STATE OF NORTH CAROLINA  
DEPARTMENT OF TRANSPORTATION

August 31, 2020

Subject: **Revised Modification Request for Section 404 Individual Permit, Section 401 Water Quality Certification and Neuse Riparian Buffer Authorization** for Interstate 40 Widening and Improvements from I-440/US 64 (Exit 301) to just north of SR 1525 (Cornwallis Road), including improvements to NC 42 and SR 1010 (Cleveland Road) in Wake and Johnston Counties, Federal Aid Project No. IMNHF-040-4(139)301; TIP Numbers I-5111 and I-4739, Division 5. Debit \$570 from WBS Element 42346.3.1.

PROJECT REFERENCE NO. 1-5111/1-4739	SHEET NO. 22
RW SHEET NO.	HYDRAULICS ENGINEER
ROADWAY DESIGN ENGINEER

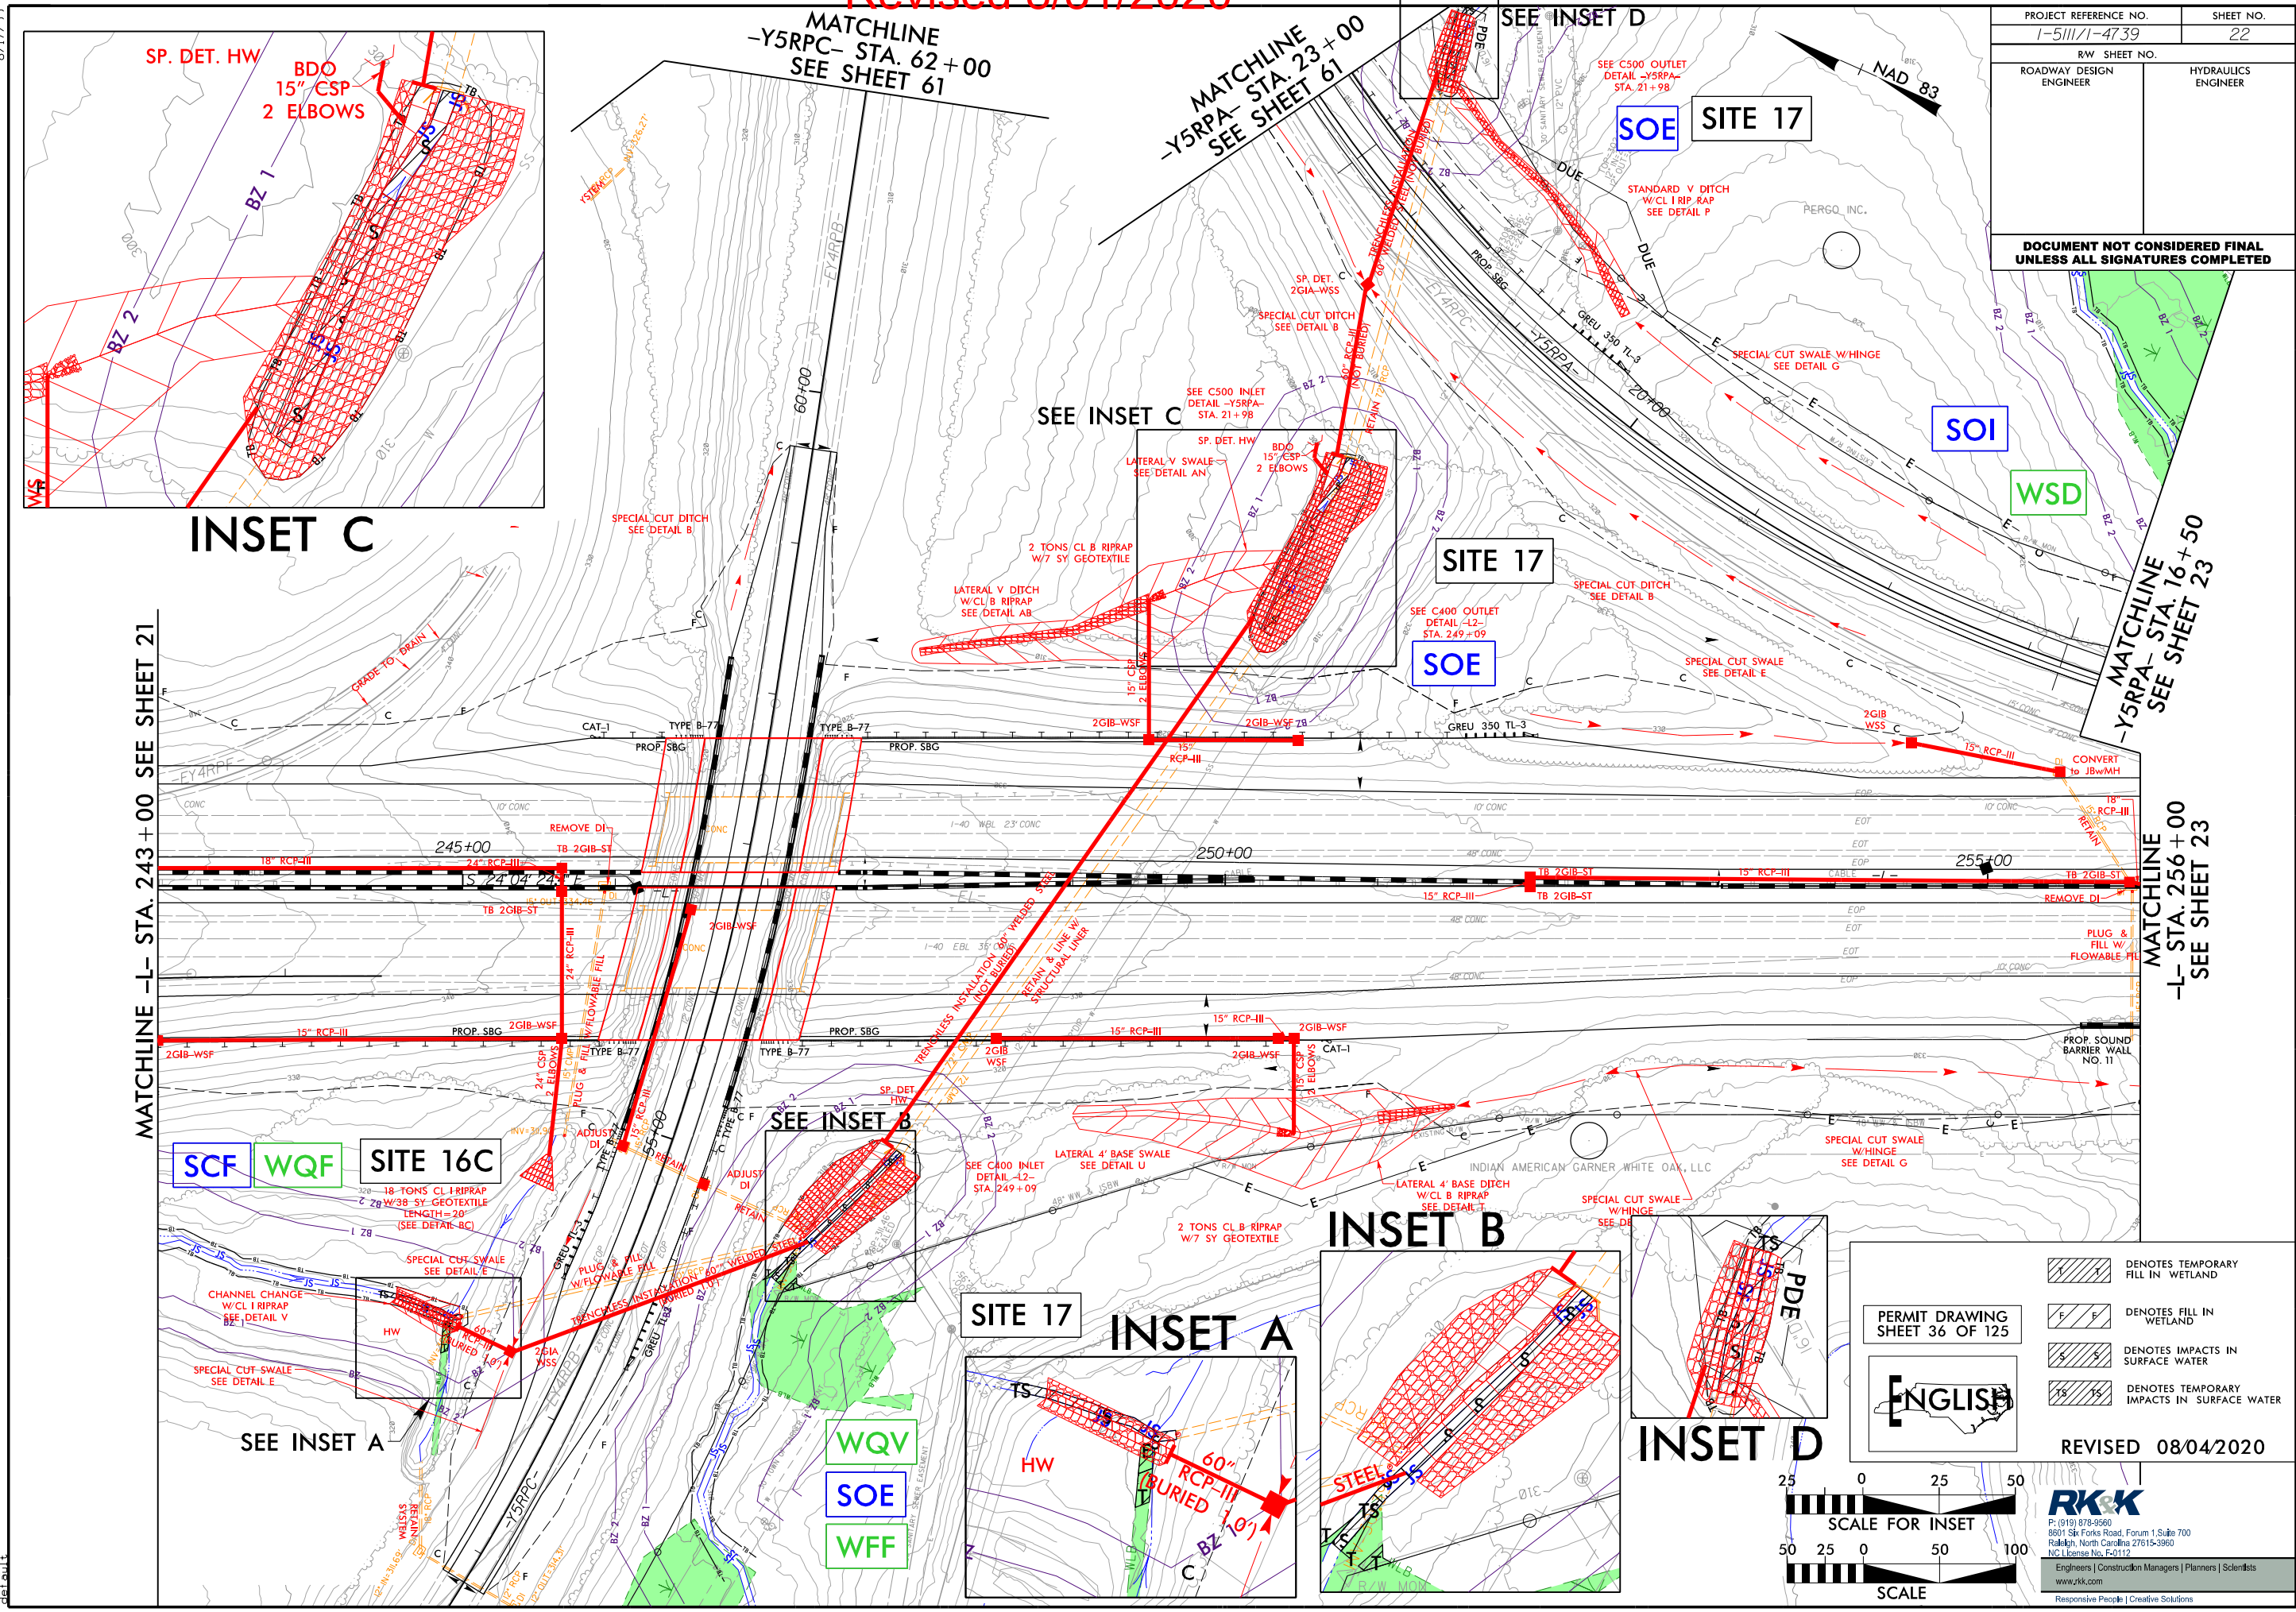
During a recent review, it was noted that the swale running along -Y5RPA- 21+00-23+00 LT (near Site 17 in the permit drawing detail B) was closer to the ramp than depicted in the permit drawings. As a result, it is funneling water behind the new 60" RCP headwall as opposed to beyond it and causing erosion. It was determined that the least invasive solution would be to install an open-ended pipe to receive the flow and discharge to Stream SOE. An elbow will be installed at the base of the slope to direct the flow towards the channel. This will prevent flow in Stream SEO from entering the proposed pipe during higher flow events. Based on the drainage area, a 15" CSP is required.

Installing the 15" CSP will not result in additional surface water impacts since this section of the SEO channel was being ripped and considered fully impacted. However, this modification does increase buffer impacts:

- + 606 ft<sup>2</sup> Buffer Zone 1 impacts
- + 1,165 ft<sup>2</sup> Buffer Zone 2 impacts

PERMIT DRAWING SHEET 91 OF 125

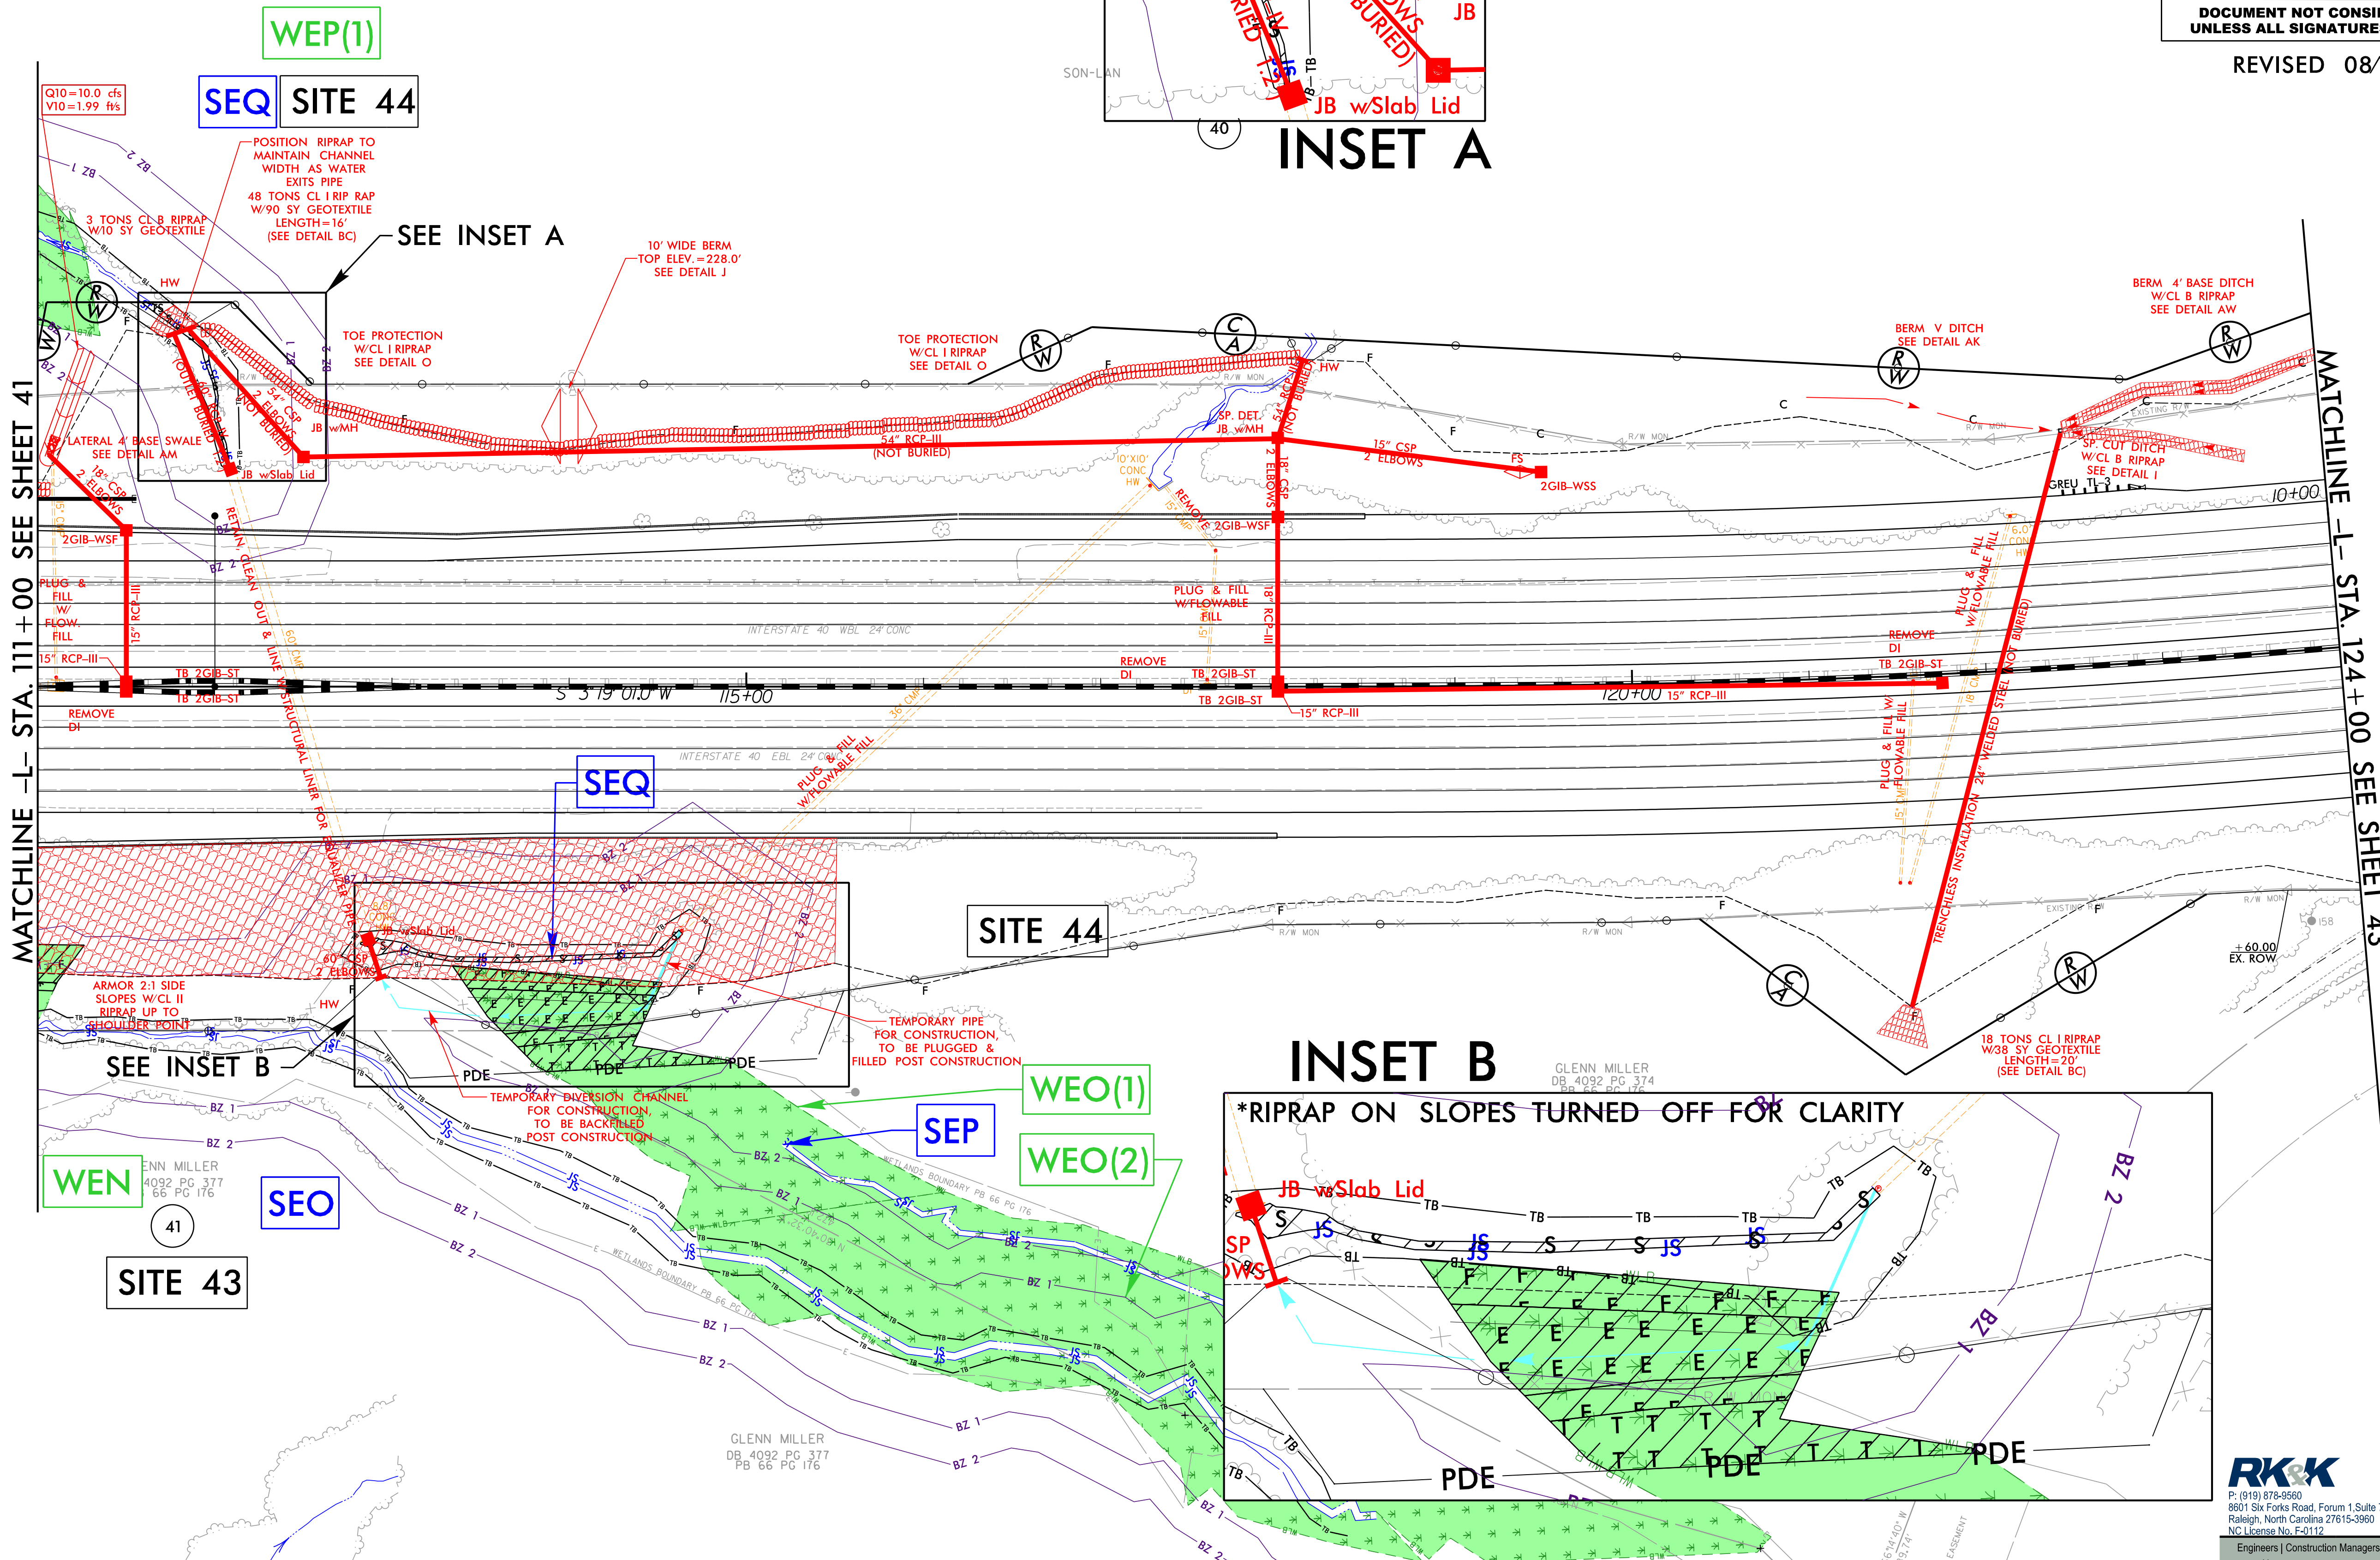
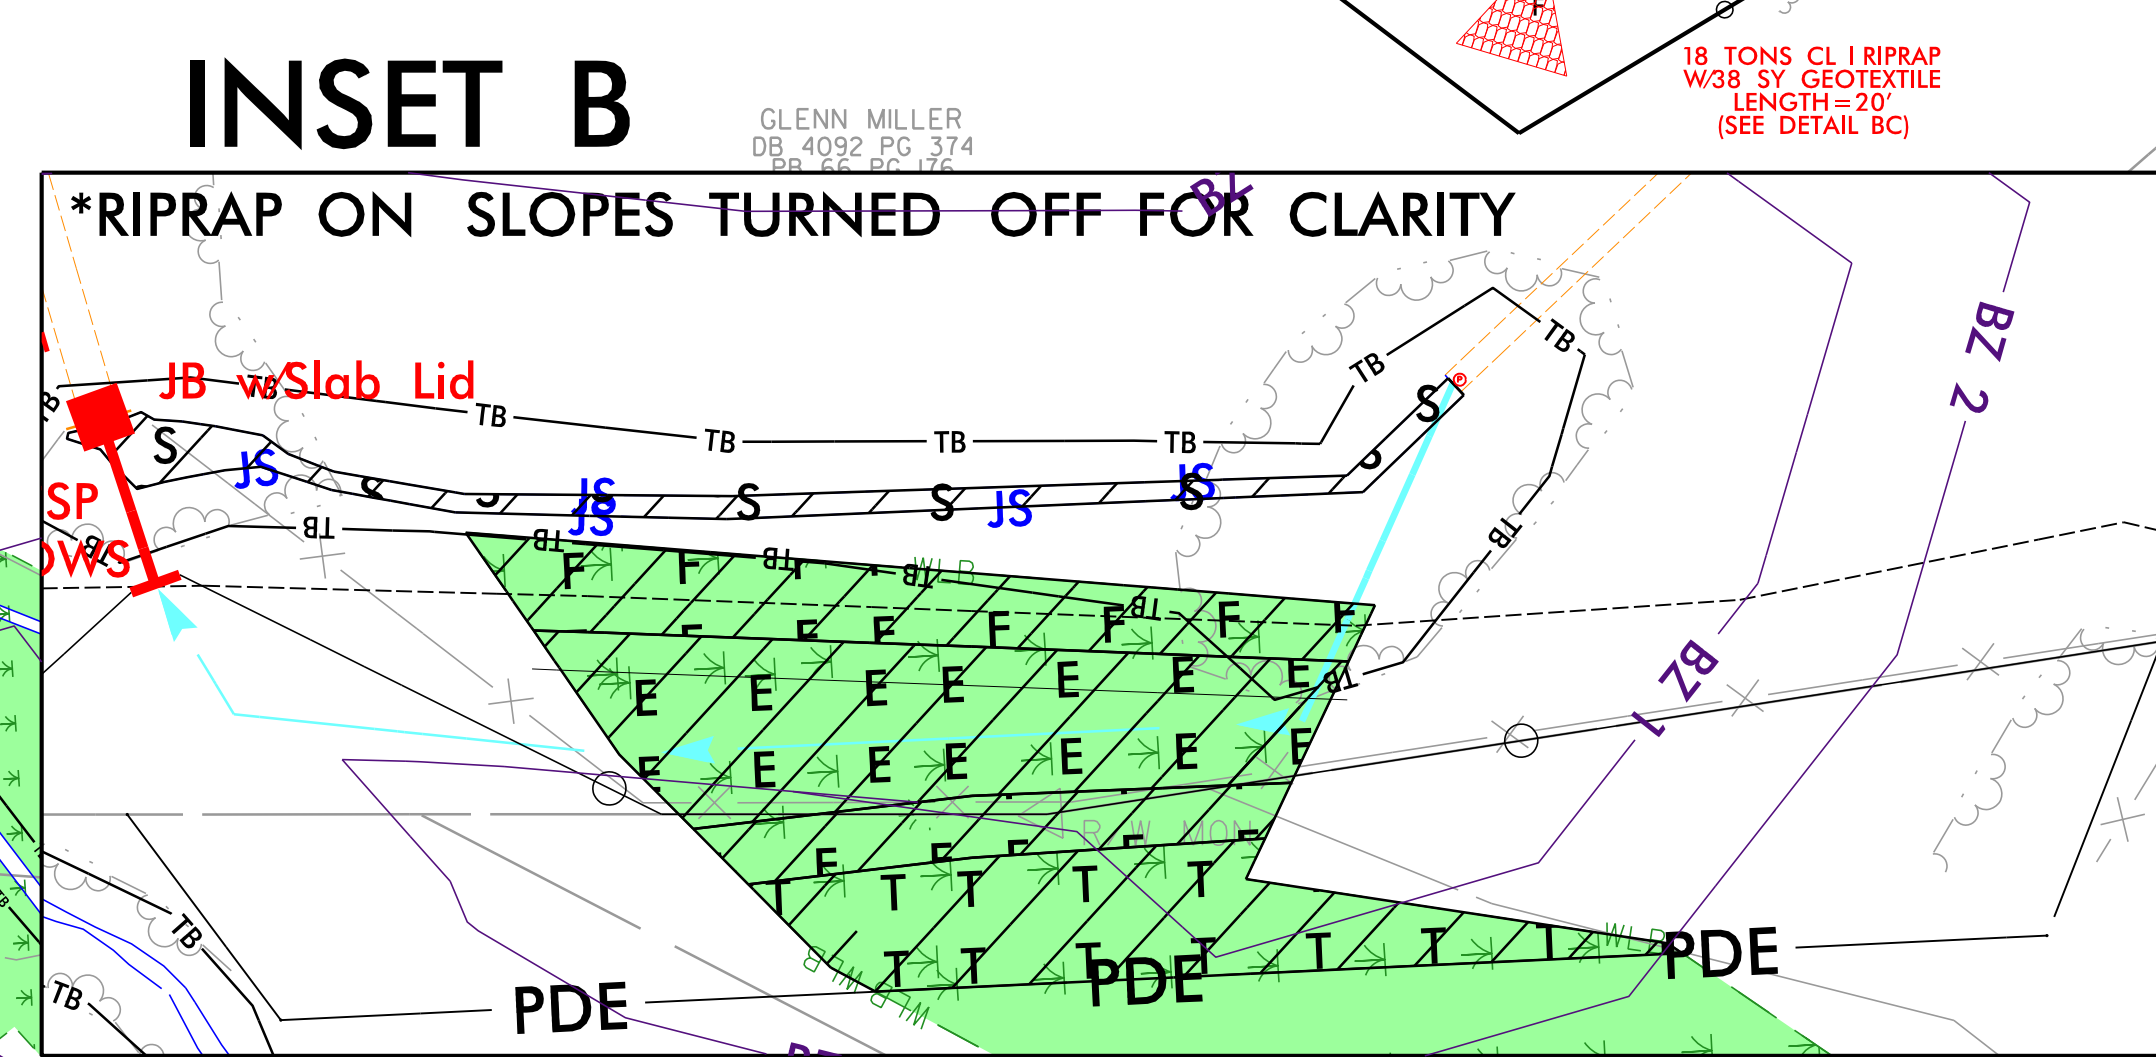
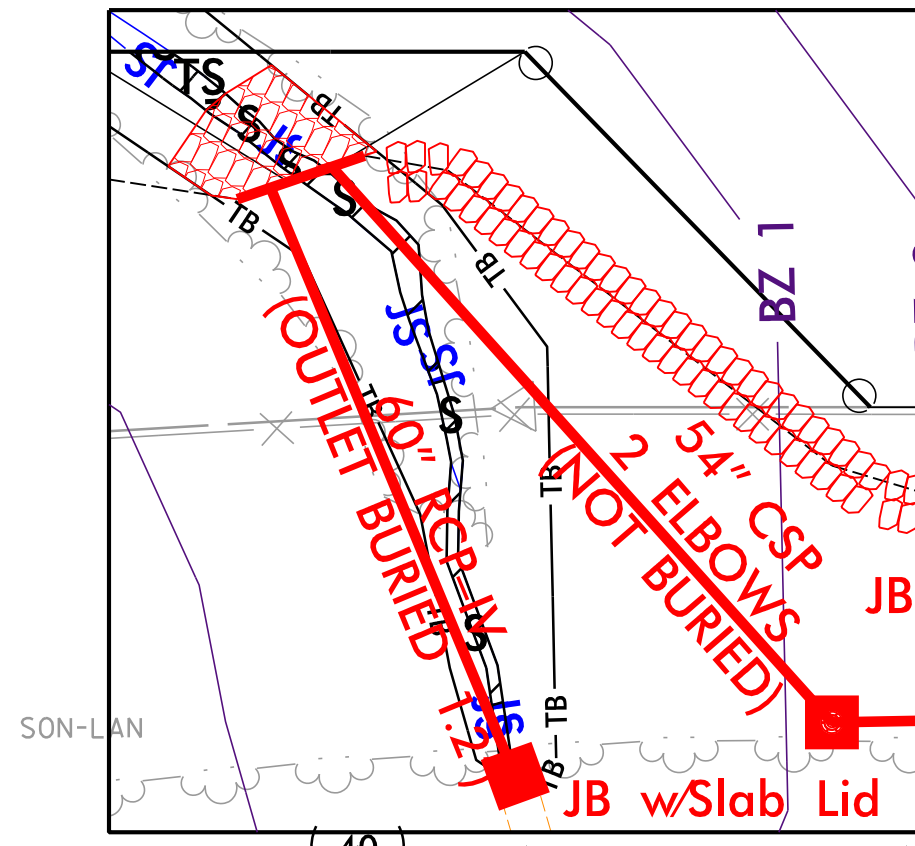
A field revision is being requested at Site 44. Currently, stream SEQ is piped from the east side of I-40 to the west side, travels along the west side of I-40 for approximately 80 feet, then is piped back to the east side. The original design kept this drainage pattern by boring a new 54" steel pipe to the west side of I-40 and then extending the existing 60" pipe to convey SEQ back to the east side. The new design proposes to install a 54" pipe along the east side of I-40 that outlets to the same 60" pipe, thus eliminating the need to bore a new 54" steel pipe. The 60" pipe will still be extended to convey any drainage from the west side to the east as well as to act as an equalization pipe. For construction sequencing, stream SEQ be placed in the relocation channel, as currently authorized, for approximately 3 months. However, this will be a temporary diversion and shown as temporary excavation in wetlands on Permit Drawing Sheet 124. Once the 54" pipe is installed along the east side of I-40, this channel will be backfilled to preexisting elevations, vegetated, and restored as a wetland.

This modification will result in the following:

- 0.043 ac of permanent wetland excavation becoming temporary
- +765 ft<sup>2</sup> of impacts to Buffer Zone 2 through abandoning the channel
